Access Compliance Report

Public Rights-of-Way

(Curb Ramps)

Intersection ID: 23437	Main Street: MOSS_RD	Cross Street: S_TRYON_ST	Location: SE
ADA ID: D0390D317D0E	Ramp Type: Perp	Initial Pass/Fail: Fail	Overall Compliance: No
Severity Score: 30			
Codes/Mitigation Info/Possible Solution		Field Measurements/Component Compliance

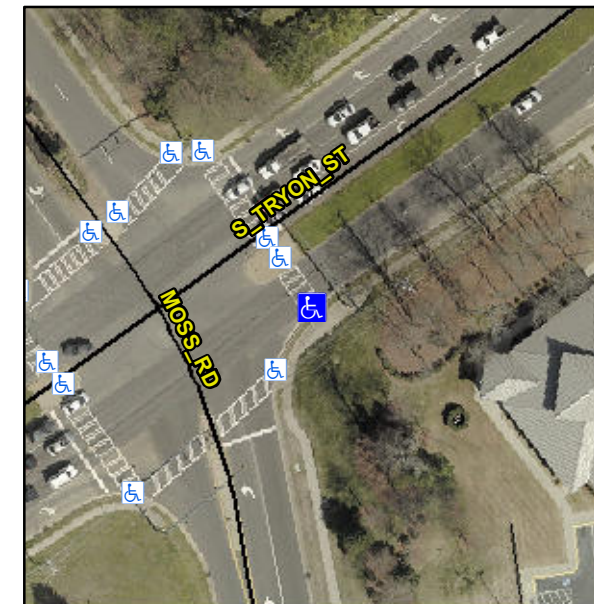
R304.5.1, R304.5.3

Compliance	Description	Data	Compliance	Description	Data
N/A	Ramp Length (in)	90.0	Yes	Ramp Slope (%)	7.4
No	Ramp Width (in)	35.0	No	Ramp XSlope (%)	5.7
N/A	Flare Type LT	N/A	N/A	Flare Type RT	N/A
N/A	Flare Slope LT (%)	N/A	N/A	Flare Slope RT (%)	N/A
N/A	Flare Traversable LT?	N/A	N/A	Flare Traversable RT?	N/A
N/A	Landing Length (in)	N/A	N/A	DWS Provided?	N/A
N/A	Landing Width (in)	N/A	N/A	DWS Contrast?	N/A
N/A	Landing Slope (%)	N/A	N/A	DWS Length (in)	N/A
N/A	Landing X Slope (%)	N/A	N/A	DWS Full Width?	N/A
N/A	Landing Curb? (Y/N)	N/A	N/A	DWS Offset (in)	N/A
N/A	Shared Landing?	N/A			
N/A	Gutter Ponding?	N/A	N/A	Gutter Slope (%)	N/A
N/A	Gutter Lip Ht (in)	N/A	N/A	Gutter X Slope (%)	N/A
N/A	Painted X Walk1?	Yes	N/A	Painted X Walk2?	N/A
	X Walk 1 Direction	To N		X Walk 2 Direction	N/A
N/A	X Walk 1 Width (in)	121.0	N/A	X Walk 2 Width (in)	N/A
	X Walk 1 Slope (%)	0.6		X Walk 2 Slope (%)	N/A
	X Walk 1 X Slope (%)	1.4		X Walk 2 X Slope (%)	N/A

Remove & Replace Entire Ramp.
